Access Compliance Report

Public Rights-of-Way

Intersection ID: 11992	Main Street: W_MOREHEAD_ST	Cross Street: GRANDIN_RD	Location: NE
ADA ID: 8116E93D76C8	Ramp Type: BlendTrans1	Initial Pass/Fail: Fail	Overall Compliance: No
		Severity Score: 1.25

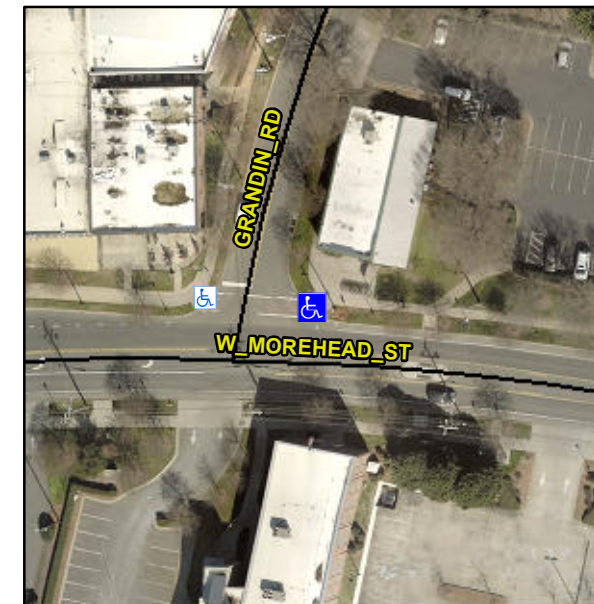
Compliance	Description	Data	Compliance	Description	Data
N/A	Ramp Length (in)	93.0	Yes	BlendTrans Slope (%)	3.2
Yes	Ramp Width (in)	48.0	No	BlendTrans XSlope (%)	3.1
N/A	Flare Type LT	N/A	N/A	Flare Type RT	N/A
N/A	Flare Slope LT (%)	N/A	N/A	Flare Slope RT (%)	N/A
N/A	Flare Traversable LT?	N/A	N/A	Flare Traversable RT?	N/A
N/A	Landing Length (in)	N/A	N/A	DWS Provided?	N/A
N/A	Landing Width (in)	N/A	N/A	DWS Contrast?	N/A
N/A	Landing Slope (%)	N/A	N/A	DWS Length (in)	N/A
N/A	Landing X Slope (%)	N/A	N/A	DWS Full Width?	N/A
N/A	Landing Curb? (Y/N)	N/A	N/A	DWS Offset (in)	N/A
N/A	Shared Landing?	N/A			
N/A	Gutter Ponding?	N/A	N/A	Gutter Slope (%)	N/A
N/A	Gutter Lip Ht (in)	N/A	N/A	Gutter X Slope (%)	N/A
N/A	Painted X Walk1?	Yes	N/A	Painted X Walk2?	N/A
	X Walk 1 Direction	To W		X Walk 2 Direction	N/A
	X Walk 1 Width (in)	100.0		X Walk 2 Width (in)	N/A
	X Walk 1 Slope (%)	3.3		X Walk 2 Slope (%)	N/A
	X Walk 1 X Slope (%)	1.6		X Walk 2 X Slope (%)	N/A

Remove & Replace Curb Ramp With Two New Directional Ramps or Equivalent.

R304.5.3
